February 19, 2021

I am pleased to offer EIR comments for your upcoming SR-67 corridor improvements

**Median / Outside Shoulder Widening & Bike Lanes
(Outside Shoulder Widening on Both Sides)**

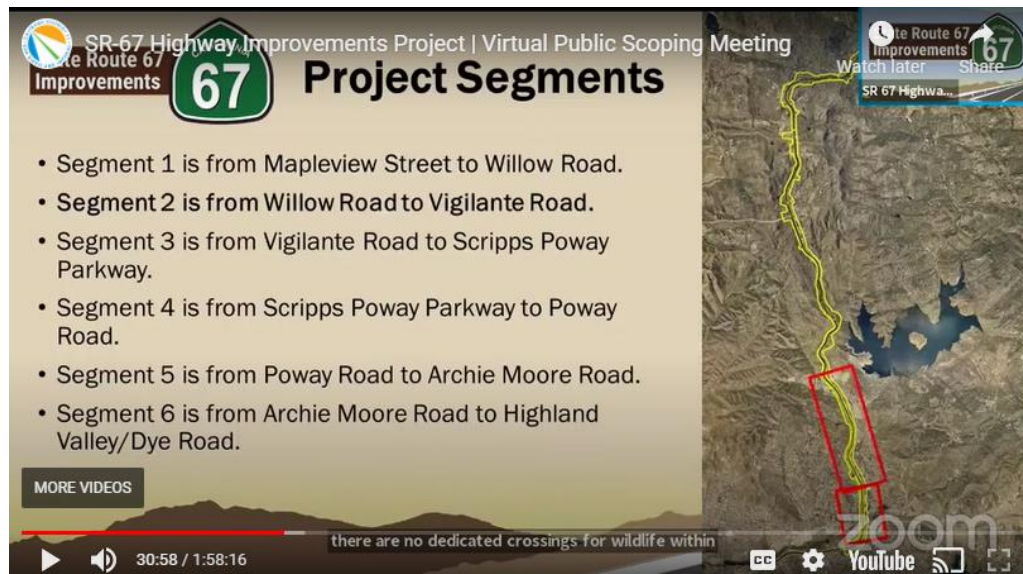
As a cyclist my preference would be for Alternative 6B. From a cyclist standpoint, having 11' of shoulder in each direction with the rightmost 6' dedicated to a bike lane would be a huge improvement over existing conditions – [documented here](#) in my presentation to Caltrans. The additional 5' of buffer on the left will make it comfortable for cyclists of all experience levels with the extra separation from the high speed traffic on SR 67. Also, one lane in each direction during normal operation may promote traffic calming, an additional environmental improvement. The wide 16" median will provide the safety for head-on collisions and does give 3 evacuation lanes in case of emergency. With a median that wide, I question the need for vertical delineators, though. Aggressive centerline rumble strips would seem to also work well for motorist safety to mitigate cross-over collisions. The delineators will not prevent out of control vehicles – won't rumble strips be better for waking up an inattentive motorist?

So please consider Alternative 6B with centerline rumble strips instead of flexposts as a primary recommendation at least for segments 4,5,6 and Alternatives 4 and 5 with a Class I path for segments 1 and 2 and a design to seamlessly integrate sections if that is the final direction. For any areas with descent, cyclists must have the option of a wide shoulder for safely maneuvering around hazards and even using the travel lane when necessary and safe to do so.
